<b>TCP/11/16(477) – 17/00334/IPL – Residential development (in principle), site of former 1 Lower Gauls, Bankfoot</b>
---

# NOTICE OF REVIEW

**PLANNING APPLICATION REF 17-00334-IPL - DEMOLITION OF DWELLINGHOUSE AND ERECTION OF 2NO. DWELLINGHOUSES (IN PRINCIPLE), 1 LOWER GAULS, BANKFOOT: OBJECTION ON FLOOD RISK GROUNDS**

Proposed Section A-A through Plot No.1

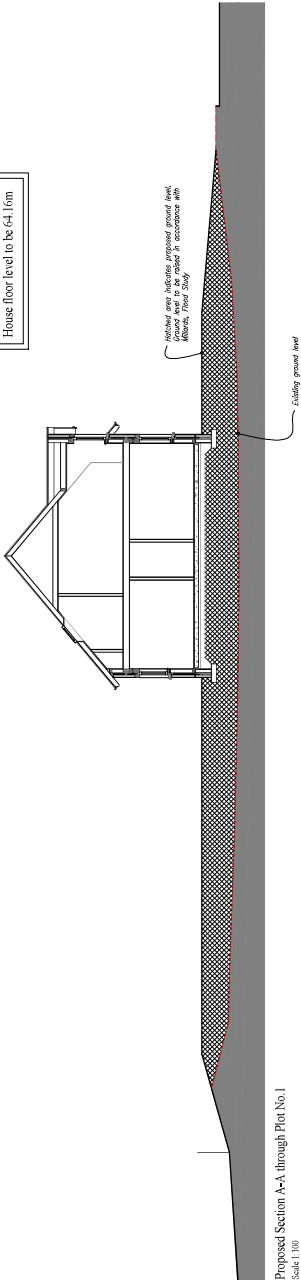
Plot 1  
Garden ground raised to 63.86m  
House floor level to be 64.16m

Proposed Section B-B through Plot No.2

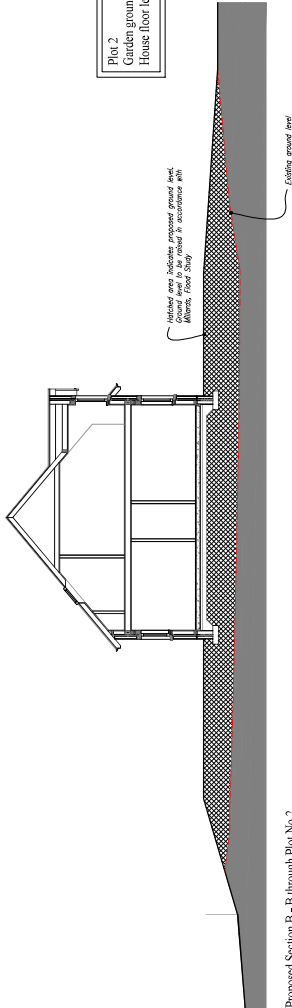
Plot 2  
Garden ground raised to 63.86m  
House floor level to be 64.16m

Figure 3 - Proposed development plans

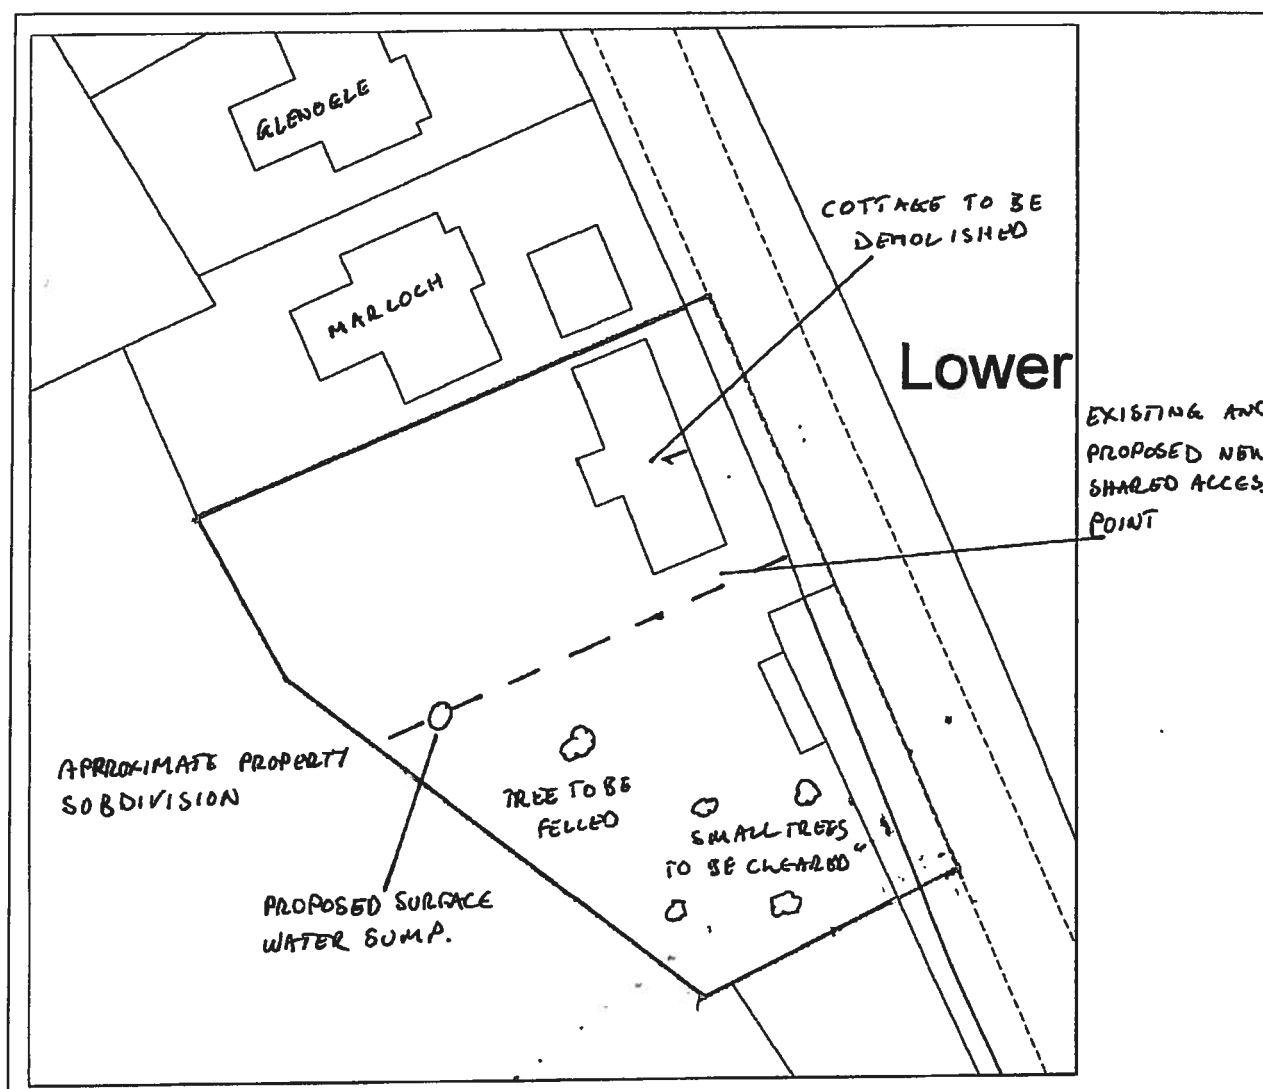
Previously, SEPA had stated concerns that the raising of garden ground to form building platforms/flood free garden ground would potentially lead to loss of floodplain. However, it was possible to demonstrate that the property at Number 2 was protected by an existing ear bund to the west and higher ground on all other sides which precluded floodwater from the site. Hence the site was deemed not to be within the floodplain, and no landraising was involved. This is exactly the same as the situation for Lower Gauls, as highlighted on Figure 2 above.

It is proposed to culvert a short length of ditch along the frontage of the site, south of the existing driveway access. This will allow garden ground and a new access to be formed. The size of pipe to be used for the new culverted length will be the nearest size up from the existing pipe diameter which is readily available, i.e. 450mm diameter.

**Flood Mapping - Existing case  
1 in 10 year event  
(25% Bridge Blockage)**

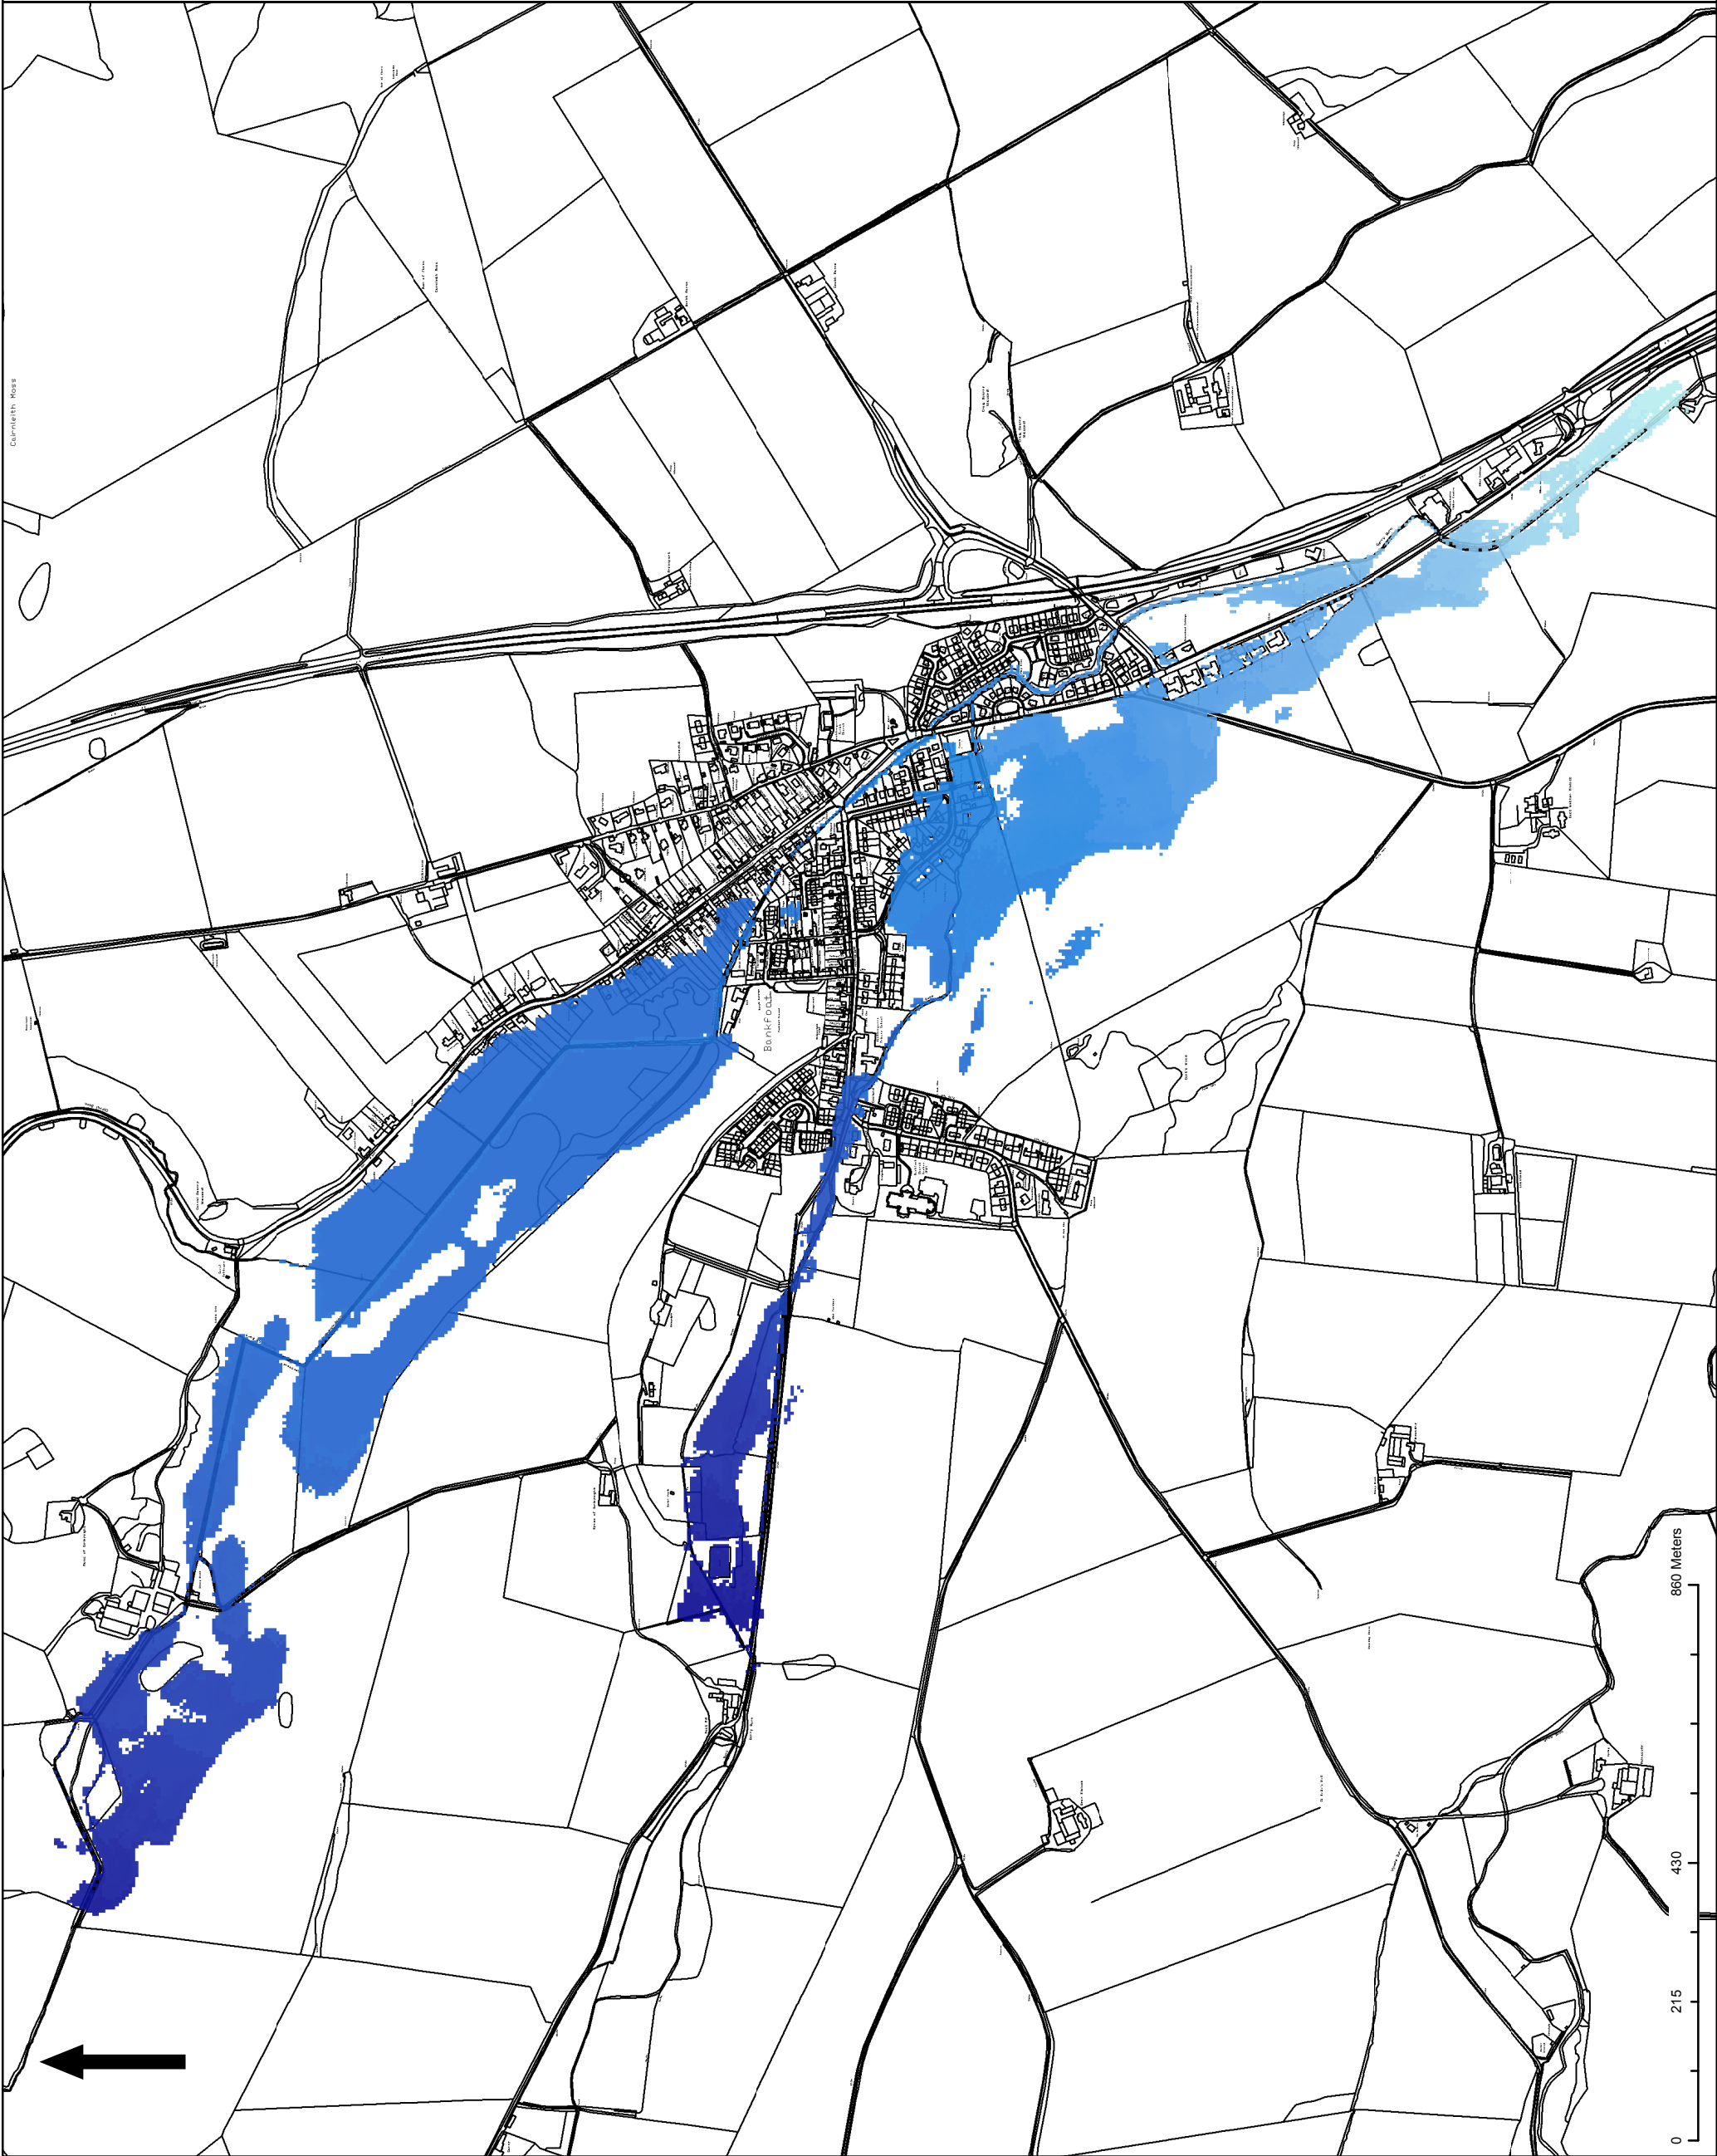
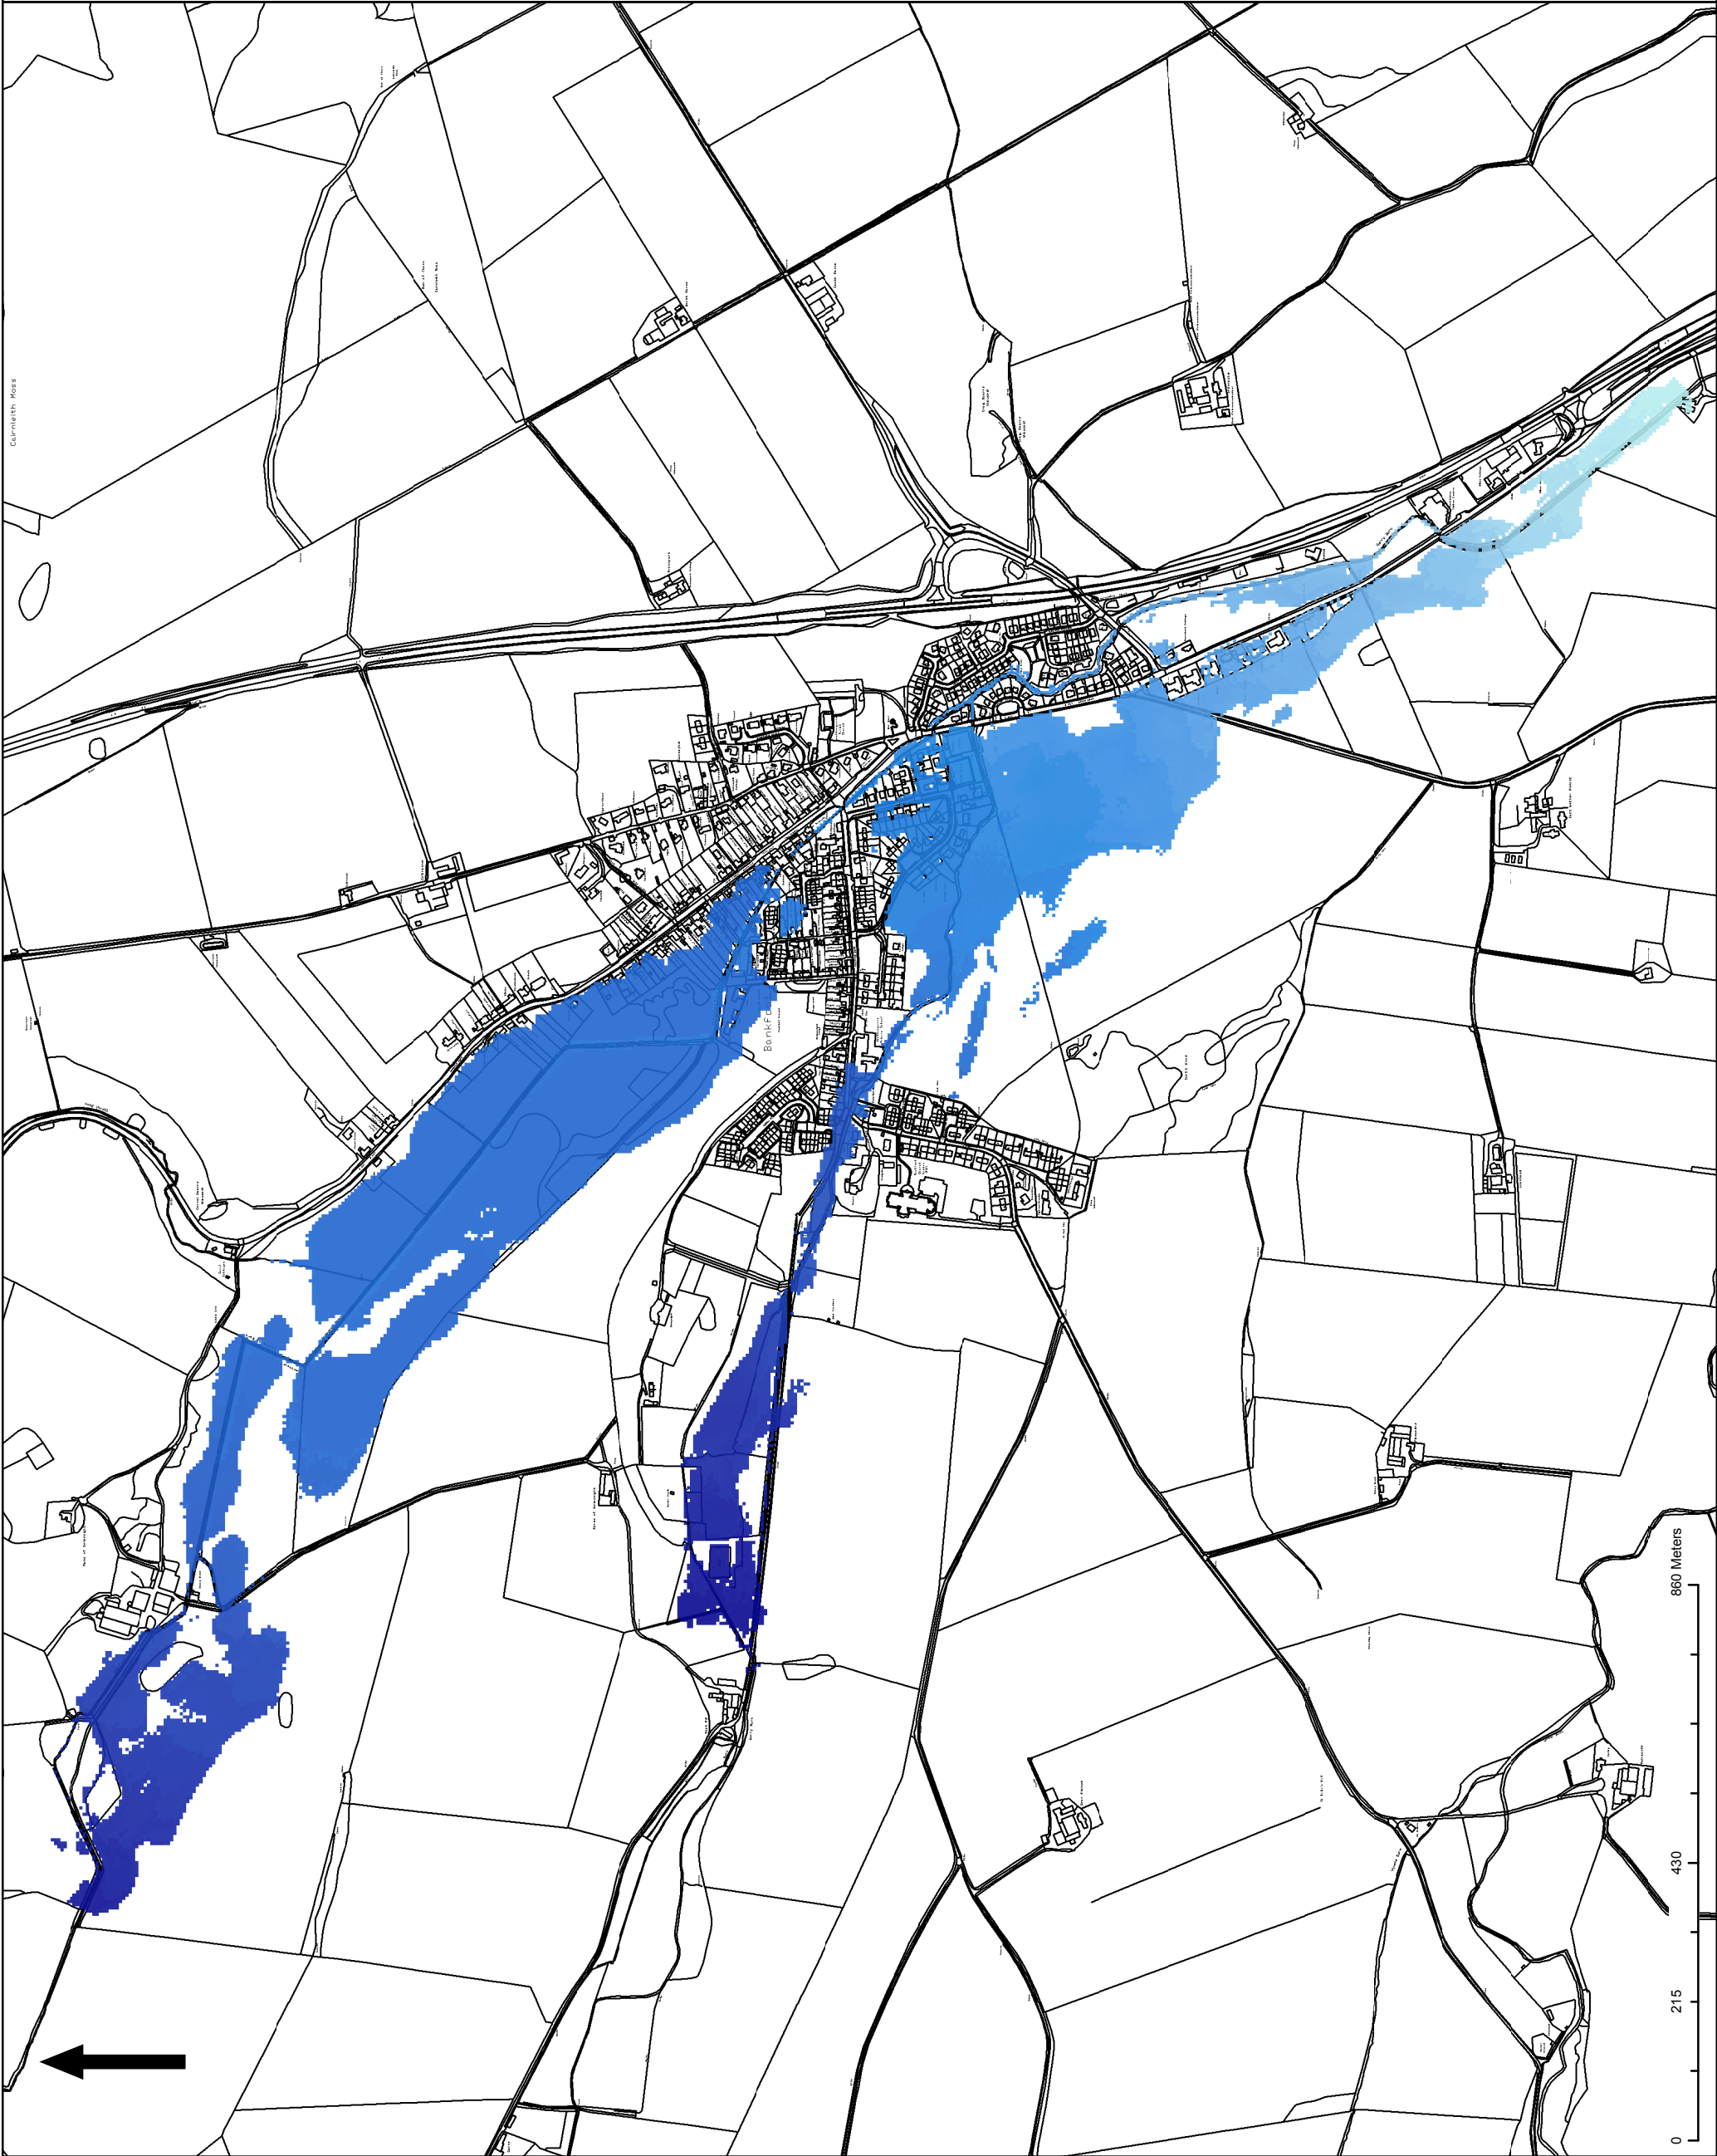
Regarding previous applications the flooding team has been consistent in its objections for the development of this site and those adjacent. The Planning department were also made aware of the delay on our side in referring the application to consultants. The decision from planning came after our response (dated 19/04/17).

To conclude, we are of the opinion that the site is part of the functional floodplain and is not suitable for the development being proposed. The applicant has not provided sufficient evidence to demonstrate the site is suitable for landraising and additional development. I trust this confirms the PKC flooding team's position on this application.
